Product Change Notification / ASER-23WWAI681

CCB 4235 Final Notice: Qualification of MMT as a new final test site for selected Atmel AT27C/BV/LVxxxPU/JUxxx products

PCN # ASER-23WWAI681
CCB 4235_Pre and Post Change Summary

PCN#: ASER-23WWAI681

PLCC 32 CARRIER TAPE

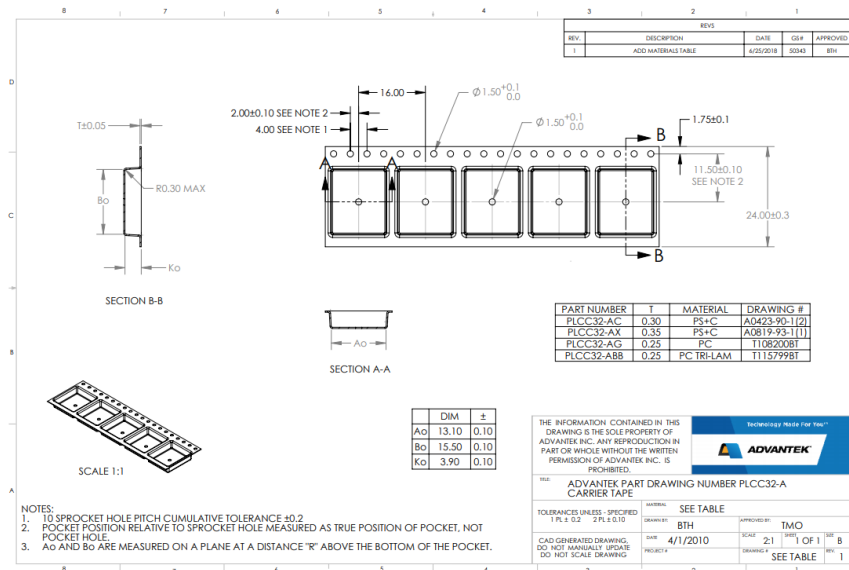
Supplier	Mfg. Part No.	W (mm.) ± 0.3 or Specific	P (mm.) ± 0.1 or Specific	$A_0 \pm 0.1$ or Specific	$B_0 \pm 0.1$ or Specific	$K_0 \pm 0.1$ or Specific	Thickness
Advantek	PLCC32-AC170.M1	24	16	13.10/-0.1	15.50+/-0.1	3.90+/-0.10	0.30 +/-0.05

PLCC 44 CARRIER TAPE

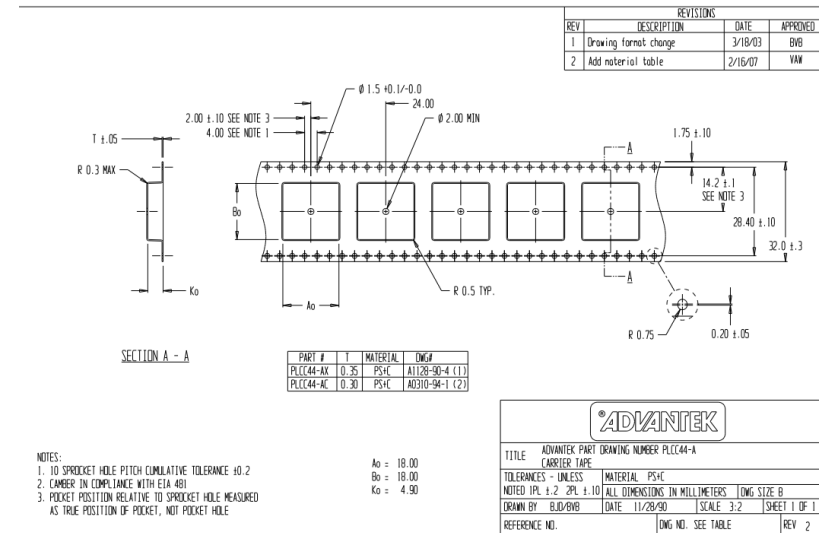
Supplier	Mfg. Part No.	W (mm.) ± 0.3 or Specific	P (mm.) ± 0.1 or Specific	$A_0 \pm 0.1$ or Specific	$B_0 \pm 0.1$ or Specific	$K_0 \pm 0.1$ or Specific	Thickness
Advantek	PLCC44-AC88.0R5	32	24	18+/-0.1	18+/-0.1	4.9+/-0.1	0.30 +/-0.05

PLCC 32 COVER TAPE (Width: 24mm)

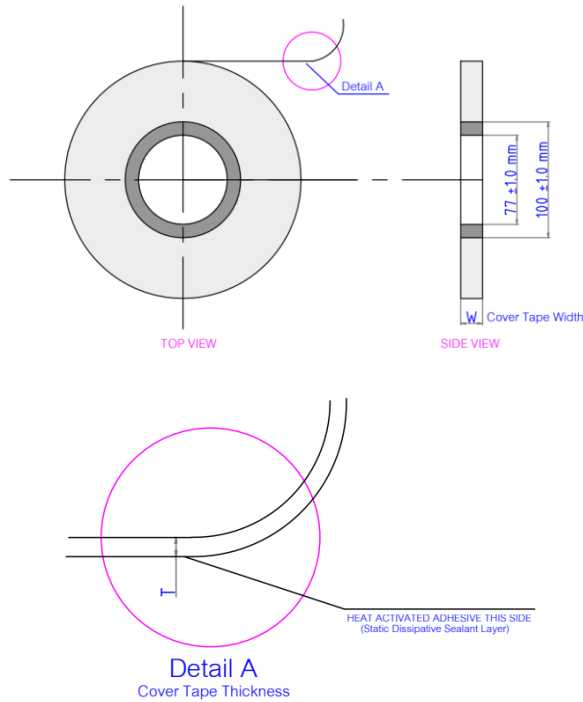
Carrier Width	Supplier	MCHP P/N	Supplier Part	Width "W" (mm)	Thickness (mm)	Sealing Mythology
24mm	Sumitomo	22102002	CSL-Z7302	21.0 +/- 0.1	0.050 ±0.010	Heat Sealing

PLCC 44 COVER TAPE (Width: 32mm)

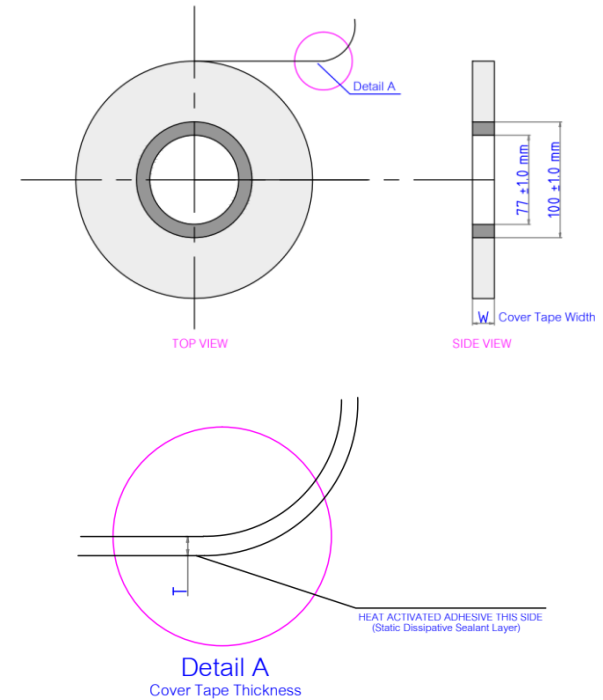
Carrier Width	Supplier	MCHP P/N	Supplier Part	Width "W" (mm)	Thickness (mm)	Sealing Mythology
32mm	Sumitomo	22104401	CSL-Z7302	25.5 +/- 0.1	0.050 ±0.010	Heat Sealing

PLCC 32L

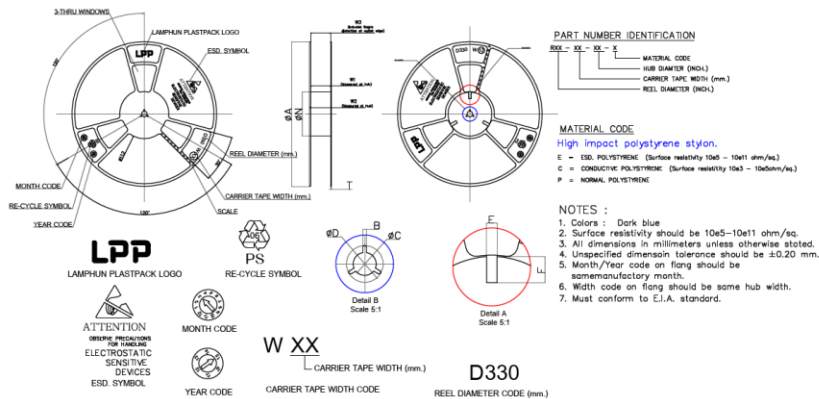
Width	MCHP P/N	Supplier Part	Hub	Color
24mm	23000024	R13-24-04-E	4inch (100mm)	Dark Blue

Description	MPHIL	MMT
Color	White	Dark blue
Diameter	329.99 +/- 1.0	330 +/- 2.0
Hub	100	100 +/- 2.0
Width	25.5 +/- 0.5	24.4 +2.00/-0.00

PLCC 44L

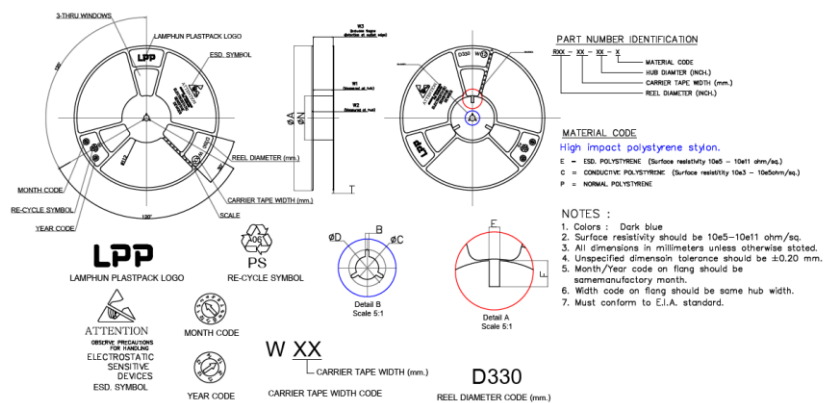
Width	MCHP P/N	Supplier Part	Hub	Color
32mm	23000023	R13-32-04-E	4inch (100mm)	Dark Blue

Description	MPHIL	MMT
Color	White	Dark blue
Diameter	329.99 +/- 1.0	330 +/- 2.0
Hub	100	100 +/- 2.0
Width	33 +/- 0.5	32.4 +/- 2.0
